# Program Bulletin

## CUSTOMER SATISFACTION PROGRAM

**SUBJECT:** ECM Wire Harness Contact

**MODELS:** 2014 Cadillac CTS  
Equipped with 3.6L Twin-Turbo Engine (LF3)

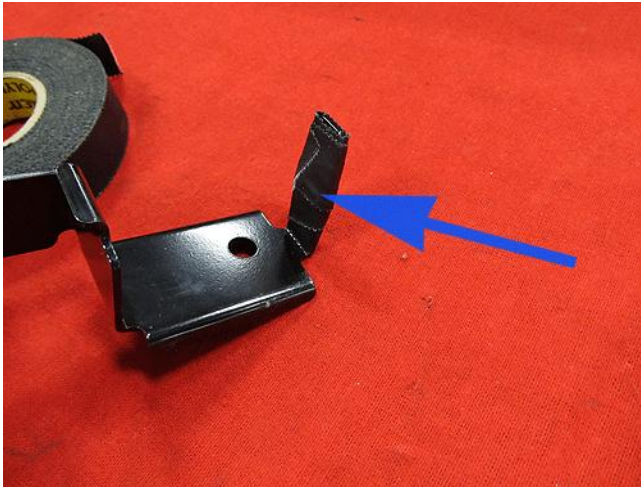
10. Remove the upper alternator harness bracket fasteners, remove and discard the bracket.

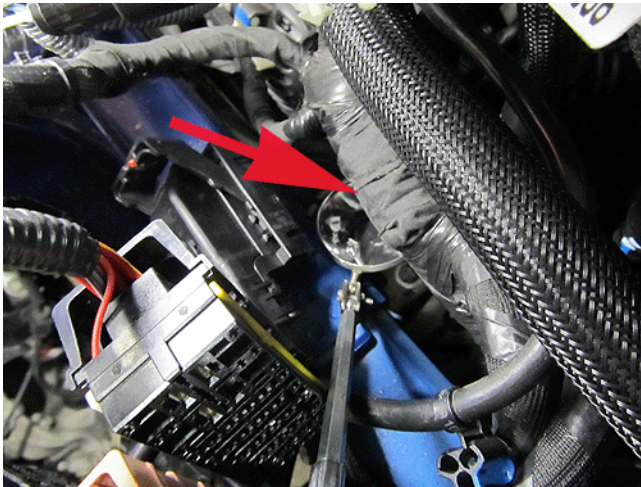
11. Prepare the new service bracket by wrapping three layers of Electrical/Anti Abrasive tape, such as Kent Automotive Part #1089482 or the equivalent, as shown.

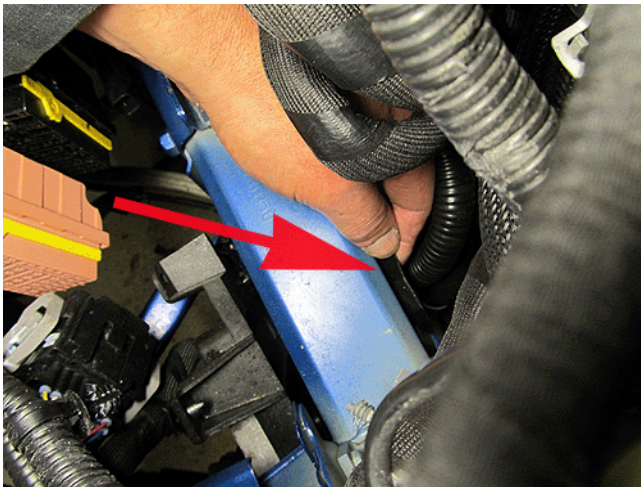
- 20. Install the material over the resistance spot welds as shown. This will prevent the rough welds from damaging the wiring harness that contacts the frame in that area.
- 21. Reinstall the Pre-fuse block.
- 22. Reinstall the ECM bracket.
